After speaking with Senior Planner Brandon Goldman, I have modified recommendations for your consideration in the Normal Ave Neighborhood Plan. Following staff guidelines for the Normal Ave Neighborhood Plan, locating similar densities of development across from established neighborhoods has been a primary objective since the Charrette process. North of Creek Drive, and west of Clay Street, the zoning plan has been changed from NA-03 to NA-02 because the proximity and density of the higher multi-family housing type would put too much traffic out onto existing (NA-02) single-family neighborhood street frontage.

Please review the attached version of the alternative connections and zoning recommendations I have identified. I hope you will consider these as viable options in your final plan for the Normal Ave. Neighborhood Project.

Submitted Illustration by Sue DeMarinis:

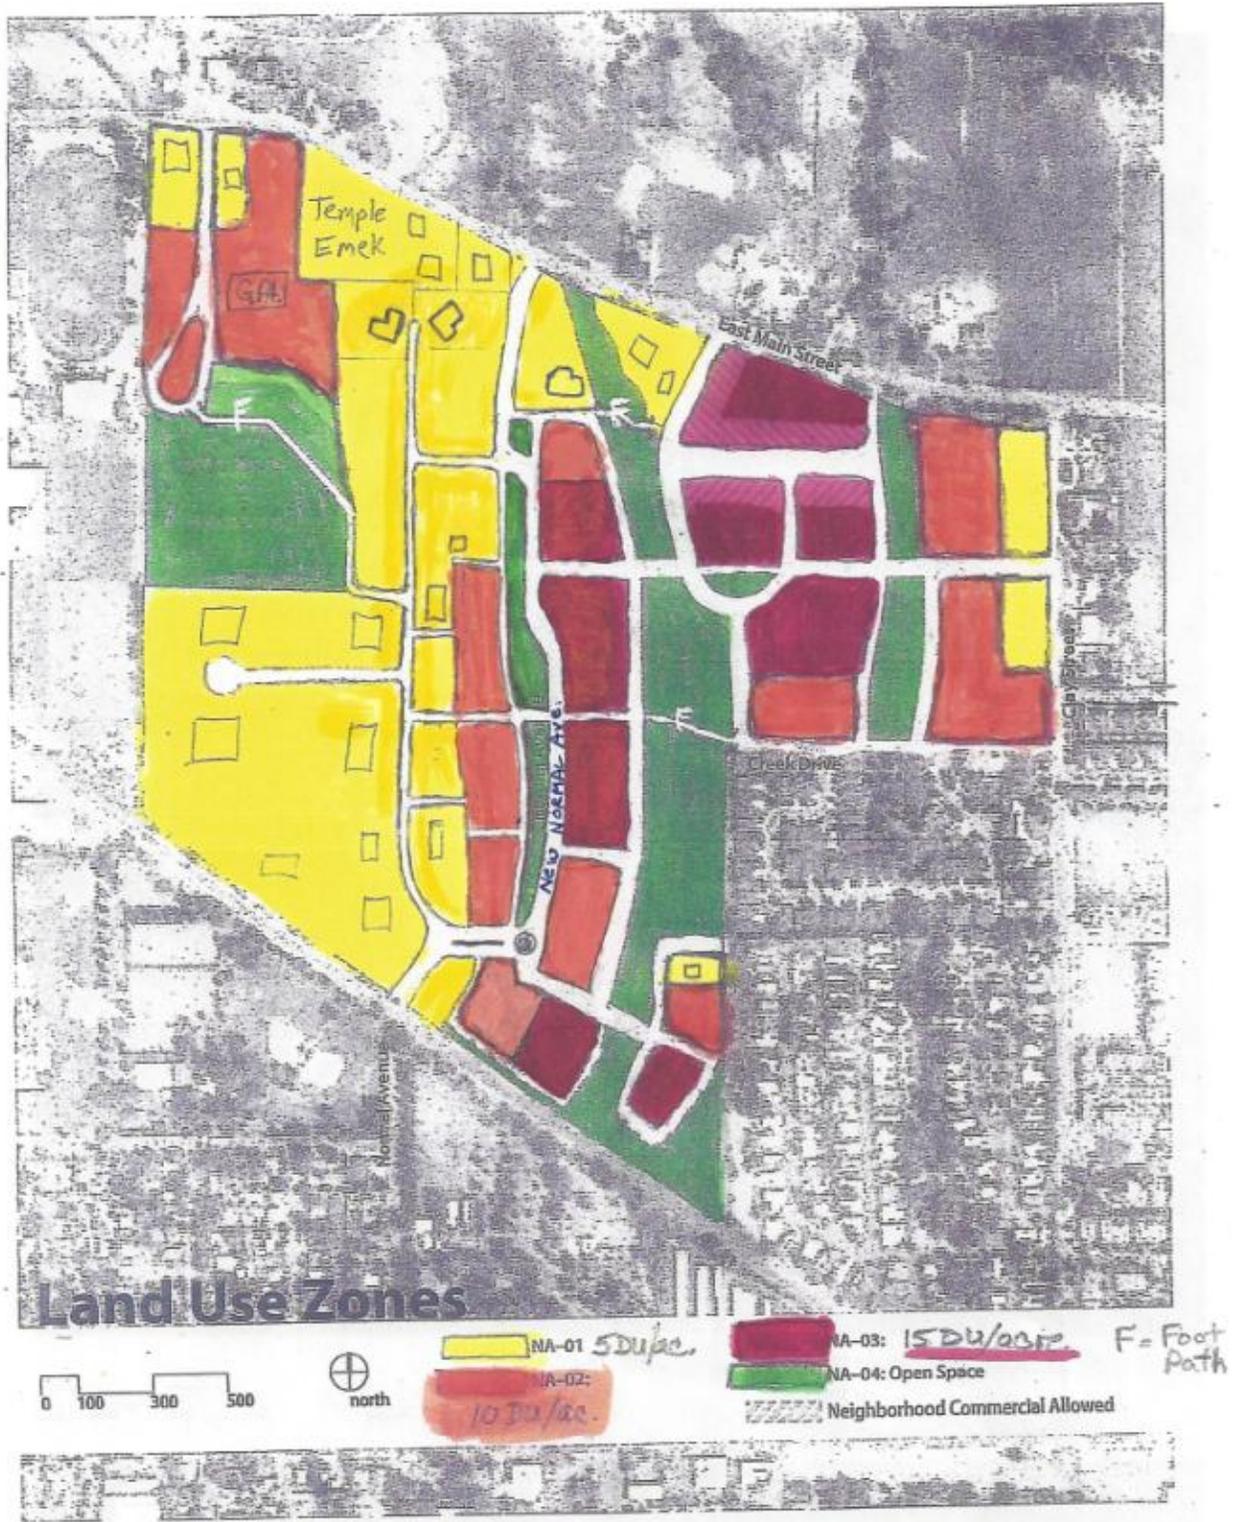
I believe this should hold true for the existing (NA-01) neighborhood along the current Normal Avenue as well. The proposed new Normal Ave. (main collector road traversing north/south) should have the most density along this "spine" road, thereby retaining the single family dwelling (NA-01) neighborhood character where it already exists along the current Normal Ave. If the housing density is shifted towards the new Normal Ave., then the need for the problematic egress across the Wetlands #9 is eliminated. The better alternative egress for a centrally located density would be to direct residential traffic **DUE NORTH** to E. Main (see option #2 below). The closer you have the higher density zoning (NA-02, NA-03) to the new main neighborhood collector road, the less vehicle miles people will have to travel through neighborhoods to egress onto a major arterial like E. Main St. The City's goal to preserve its natural areas, especially its largest designated wetland, will then be possible.

1. If connectivity is proposed by extending the current Normal Ave. through to E. Main St., the following **problems are encountered**:

a. The connector road would be a pretty *tight fit* restricted between existing structures, and even *necessitating the demolition* of some.

b. The potential intersection with E. Main St. from the existing Normal Ave. would suffer the consequences of its *proximity to the blind curve* hindering line of sight of oncoming E. Main traffic from the west, and making for a very dangerous left turn onto a main arterial.

c. The City planners have made great efforts to create a road that doesn't produce a *straight shot* through the project (from the RR tracks to E. Main). Connecting traffic would see a straight line through the current Normal Ave to continue directly to E. Main, where speeds could increase to 30 mph (similar to the problem on Faith St.). Without that straight line connection, a more central "spine" route using the new Normal Ave., with its circuitous design, will require behavioral modification as it slows vehicular speeds, making it safer for cyclists,

2. If connectivity is proposed by extending the "spine" road (new Normal Ave.) through to E. Main, you **solve a multitude of problems:**

- a. There are *no structures which would need to be demolished* and, due to lack of nearby existing buildings, the road would not need to be a tight fit or restricted in its placement.
- b. The intersection onto E. Main would have *twice the visual clearance* distance since it is further away from the blind curve in the road (along Temple Emek property) than option 1's hazardous egress.
- c. With the zoning density more centrally shifted, this egress option is closer and more accessible for residents, with *less vehicle miles* required to reach the main arterial of E. Main.
- d. The visual *straight shot North/South road is eliminated* and through traffic will more likely be development/resident related and safer. The current Normal Ave. will retain its neighborhood feeling and safely encourage pedestrian/cyclist multi-modal use to open space and school zones.

The City has housing types which it needs to provide for all types of residences, as well as simultaneously achieving density goals for the Normal Ave Neighborhood Project. **Rezoning the land and its uses into the center of this project** will allow for economy of scale, with full block lengths accommodating multi-family dwellings and their required parking areas. Transitioning out from this core (NA-03) zone, cluster cottage-type housing (NA-02) around common greens can develop. The single family (NA-01) character can then be retained in the existing neighborhoods on the edges of the project area. The overall density of the project will remain with approximately the same number of dwelling units (450) as outlined in the most recent iteration of the Planning Land Use Zone Map.
